## Comments for 2017 A117.1 draft for Final Resolution

42 ballots were returned. One ballot was abstain. The remainder were approve all committee actions with the following exceptions.

Table at 36" height with 3" high bottom rail.

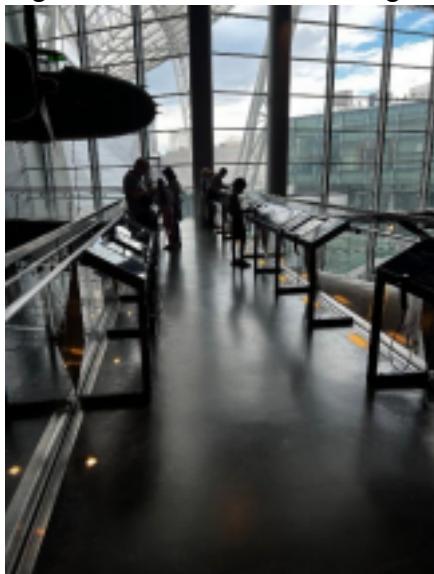
I am requesting a move back to 2017 language. This needs to be held for next cycle so that this can be addressed in a manner that is more comprehensive.

While I agree the extra height is a good idea for under stairways, making this universally required does not work for many other protruding objects. While this says 'headroom height', this literally applies to anything that is above 27" because if Section 307.2, Protruding objects.

I think any of the following configurations pictured below would stop someone from walking into them, but would not comply with the way we have the new language written. An alternative means would not comply with 10" minimum.

Following are many examples that do work that would not meet the current

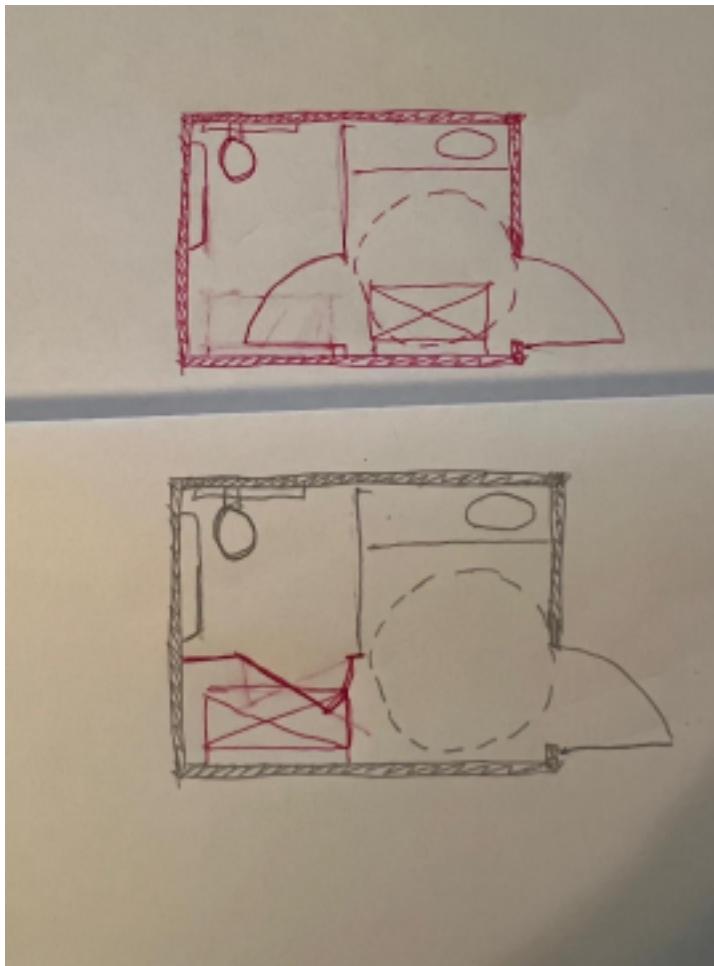
**Proposed resolution:** The issue is for the one and two compartment toilet rooms. By forcing the baby changing table out of the accessible compartment into the room it will most likely adversely affect accessibility by either losing the large stall, or obstructing access for everyone. Please revert to the 2017 text so that we can address this more completely next cycle. Below is a picture that was sent to me illustrating the issue in a two compartment toiler room.

This is what will most likely happen in single compartment

Of, if not required, the baby changing station will be removed totally. I found information no the web that only 5 states have laws that require baby changing stations. The A117.1 requires that the same amenities be provided in the men's and women's bathrooms, so this could not even be provided in just one bathroom.

**Staff note:** Diaper changing tables are not permitted to overlap the water closet clearances in a compartment or in a toilet room per Section 604.3.3.

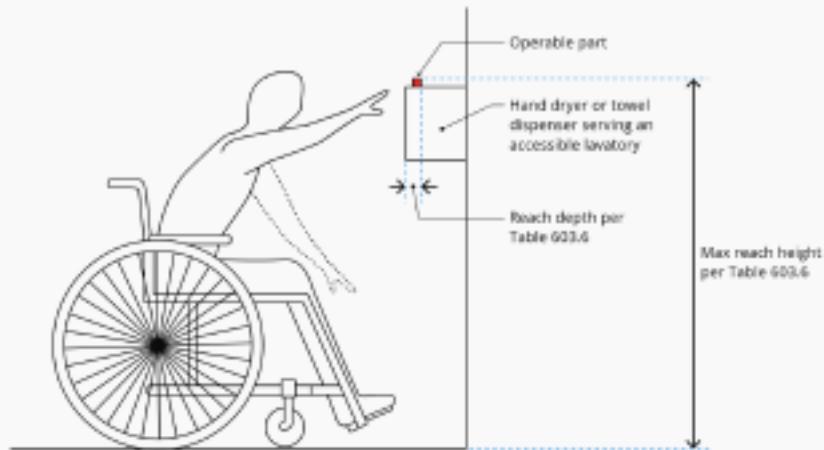
Agree with mod I suppose, but we're typically not providing a mix of PT or HD units with different operable part depths. It's typically the same unit in 2 or more locations, but the reason statements are maybe misinterpreting this table. Is the reach depth the operable part on the unit itself or the reach depth over a counter. If it is supposed to be indicating the reach depth over a counter than please provide clarification, a figure to assist, and someone tell Upcodes to revise their figure below.

I'm not sure this table is necessary or makes sense on its own, but there needs to be a figure like below to eliminate misinterpretation.

**note:** The issue seems to be more with the current text rather than the revised text. The figure is not correct.

Editorial was asked to review this change for clarification. Technically the sentences deal with different requirements. Operable parts on one towel dispenser/hand dryer has to meet the enhanced reach table, and one could meet the standard reach over an obstruction.
